STATE OF NORTH CAROLINA
DEPARTMENT OF TRANSPORTATION

Minutes of Pre-Bid Conference

PROJECTS: WBS 33203.3.1 (B-3657) Haywood County Bridge No. 9

REVISIONS						SHEET NO.	
NO.	BY:	DATE:	NO.	BY:	DATE:	2	
1	LKA	3/15/11	3			TOTAL SHEETS 26	
2	LKA	3/22/11	4

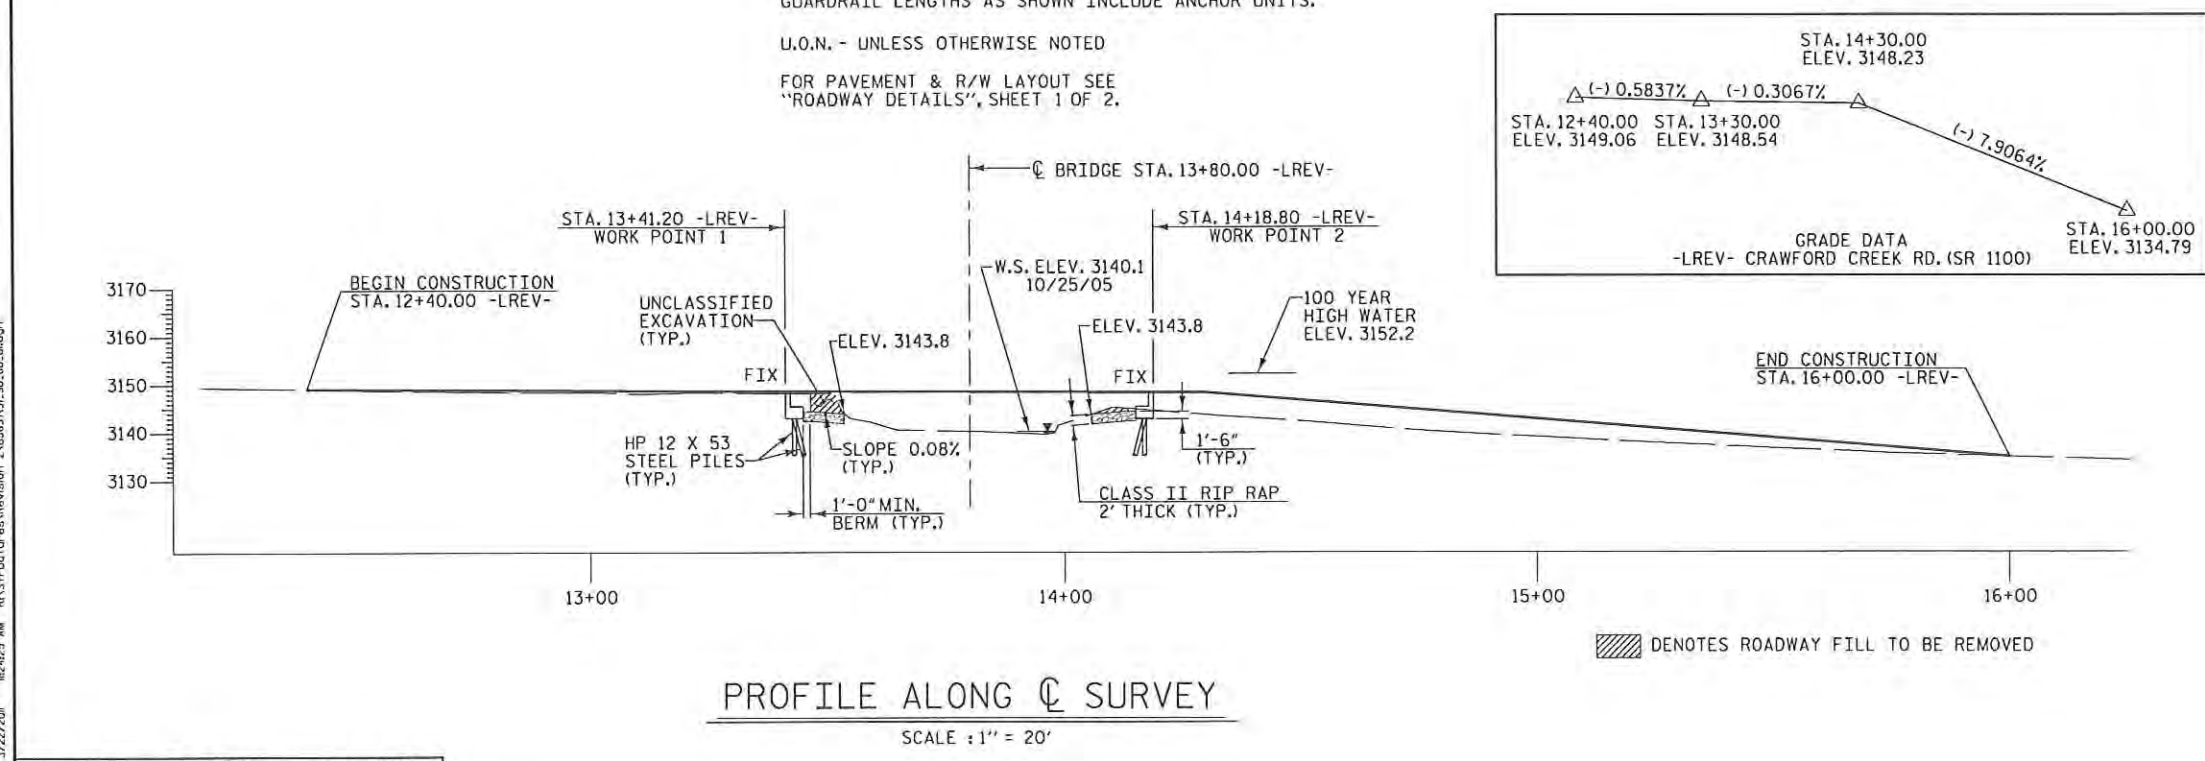
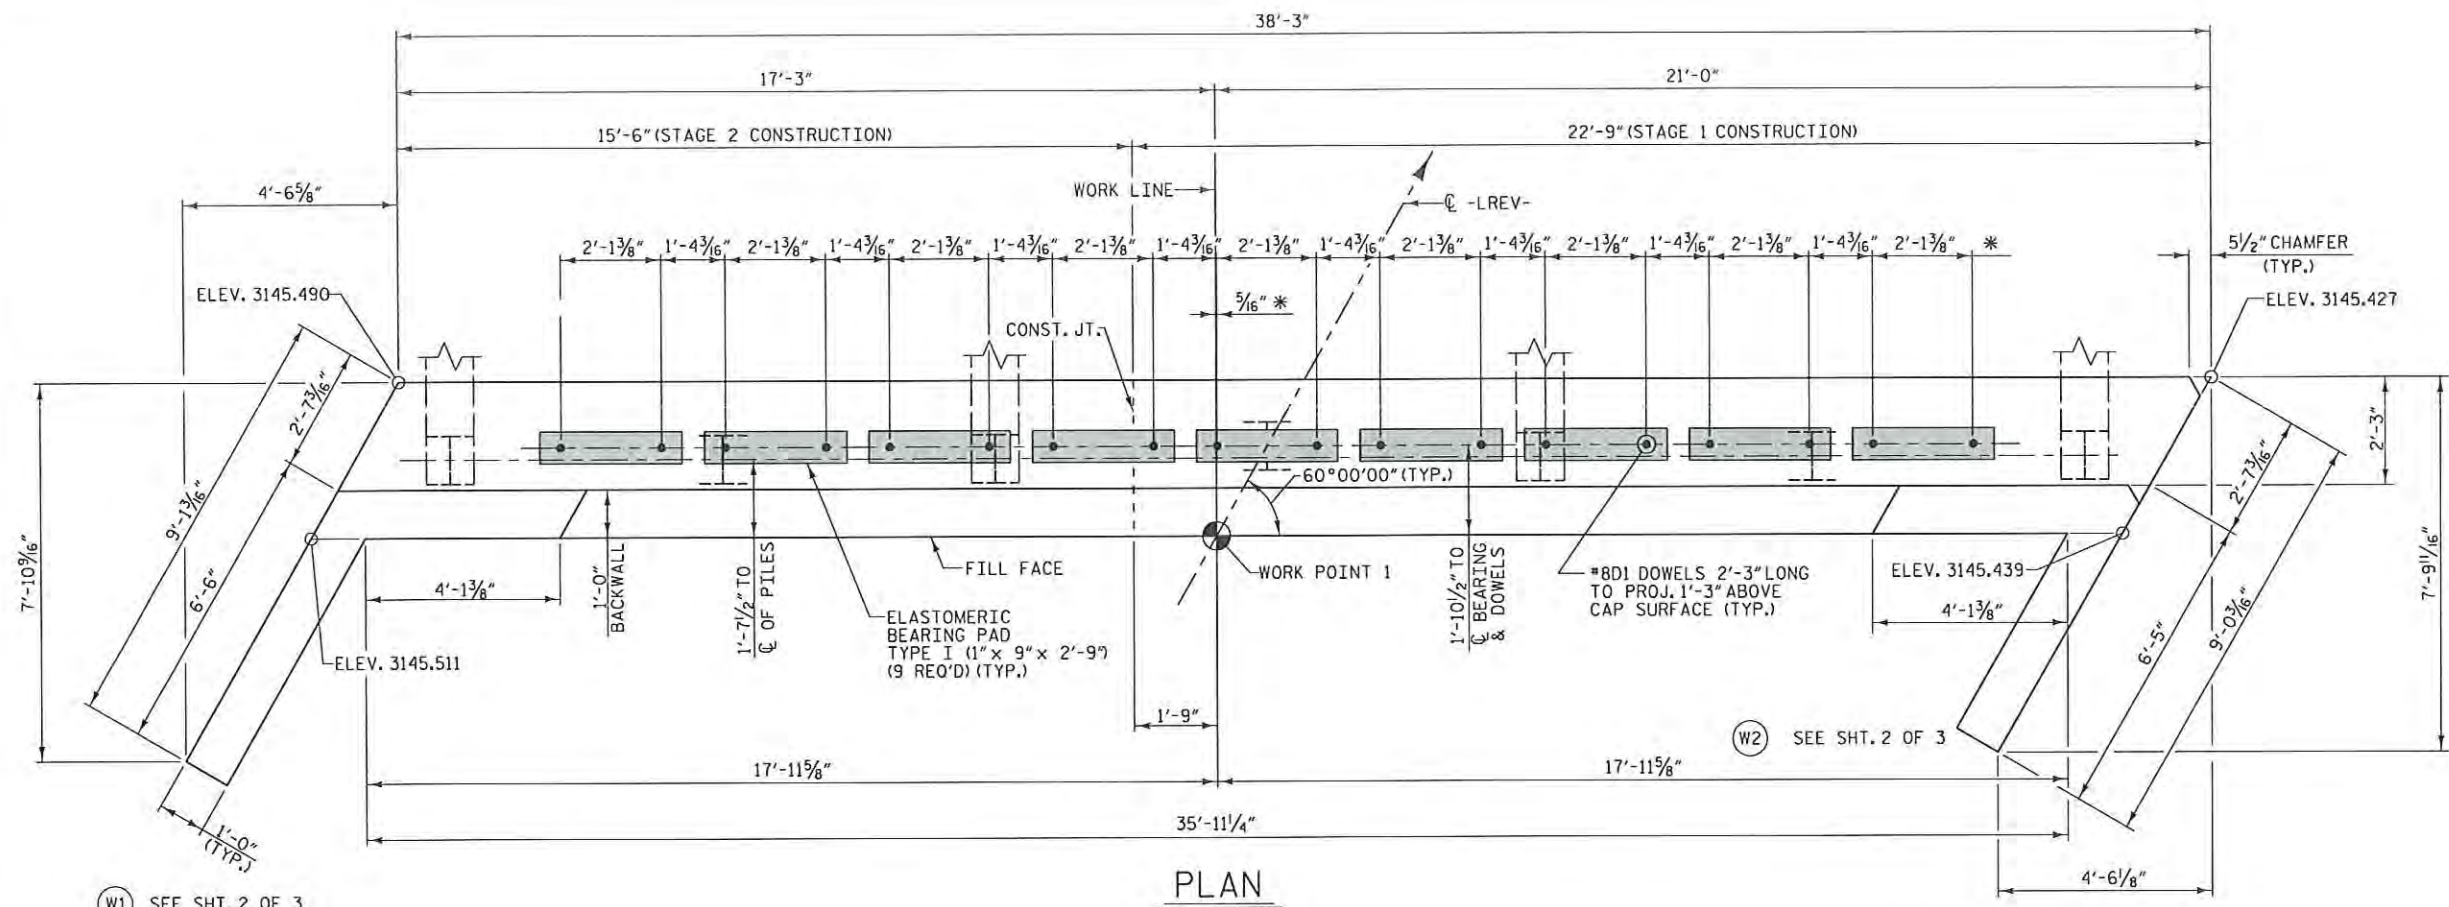
2. The contractors were informed that the backfill detail had been added to plans. Sheet no. 2 had been revised to show the 4” perforated drain pipe and outlet pad for the backfill. Based on contractor questions since the pre-bid meeting the limits of the temporary shoring have been revised on the end bent 2 side of the project. The revised plan sheet no. 2 and revised bid sheet are attached to these minutes.

SUBSTRUCTURE
 END BENT 1

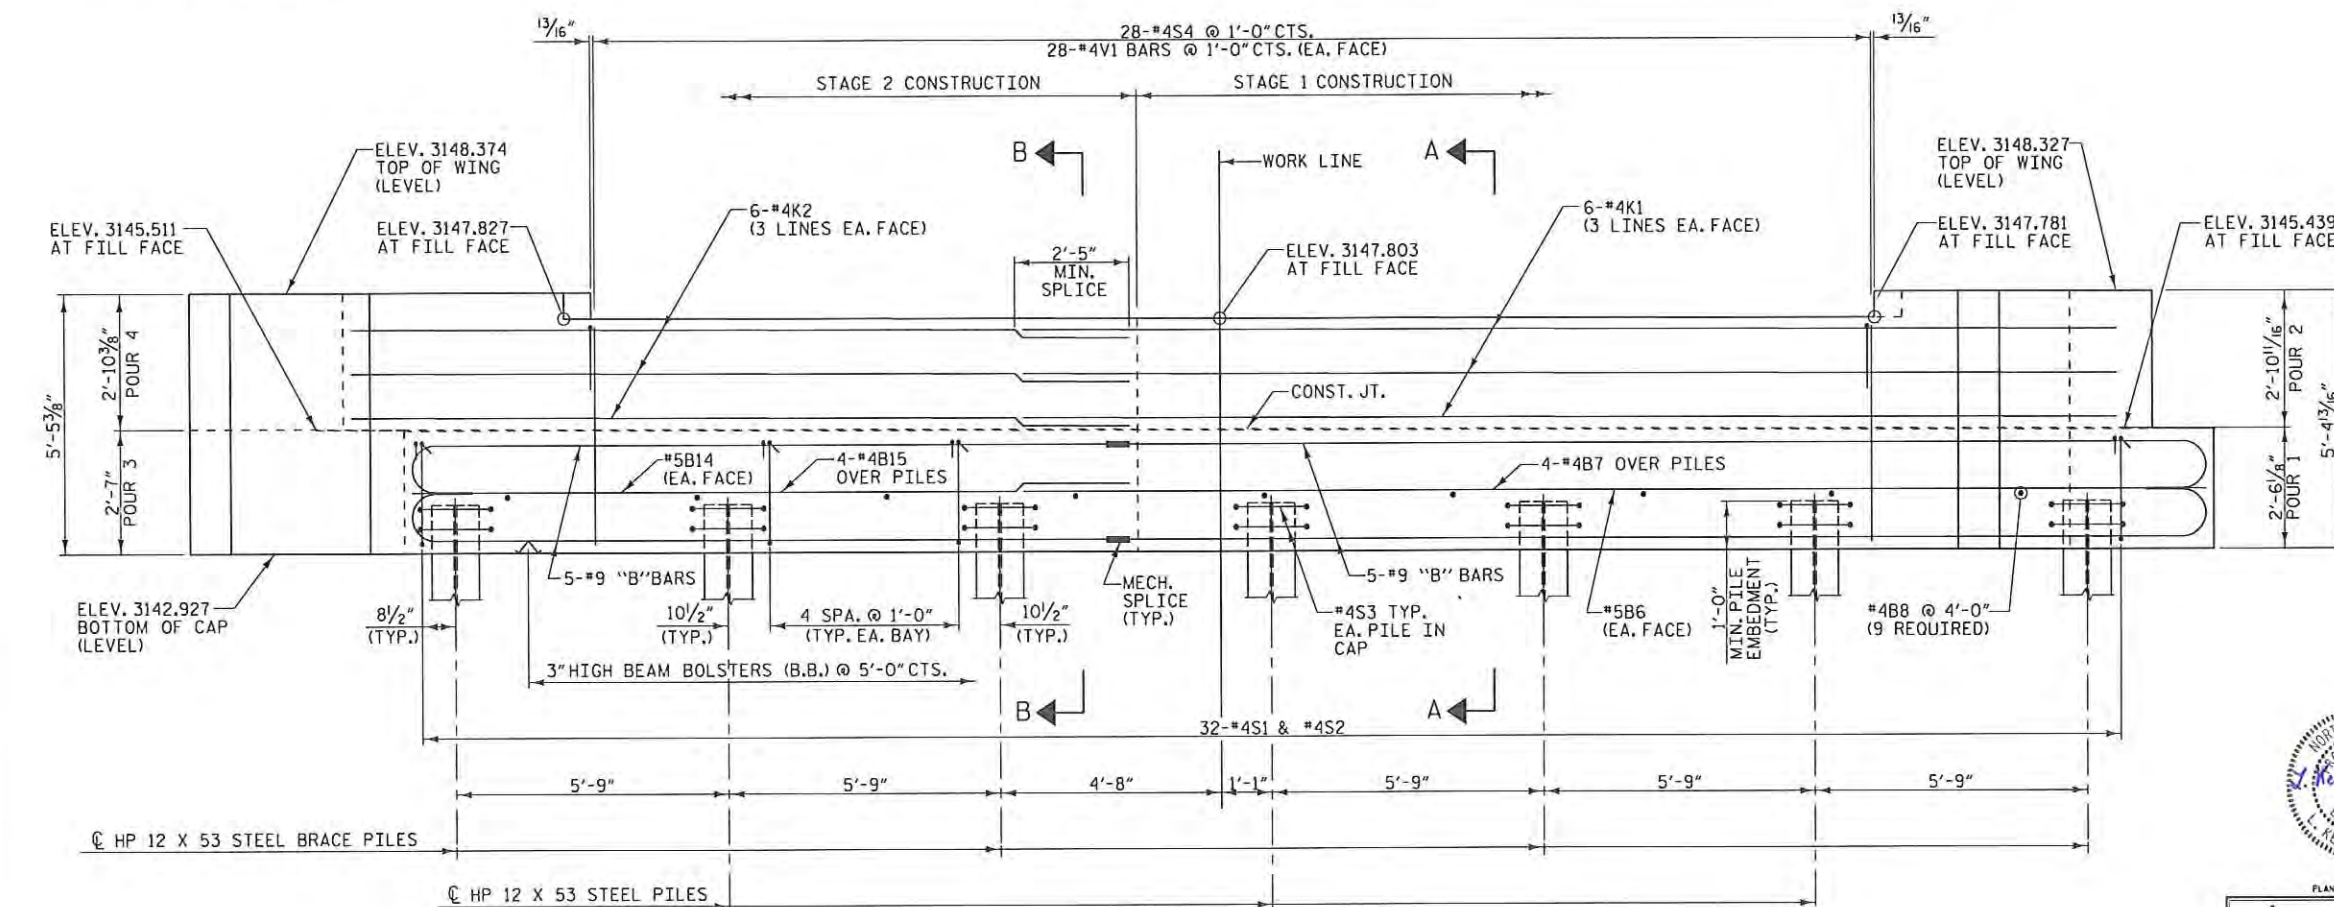
4. The backfill detail has been added to sheet no. 21 and notes were added to sheet nos. 16 and 19 referencing the back fill detail on sheet no. 21. These revised plan sheets were handed-out at the pre-bid meeting and are also attached to these minutes.

△ FOR BACKFILL DETAILS, SEE END BENT 2 SHEET 3 OF 3.
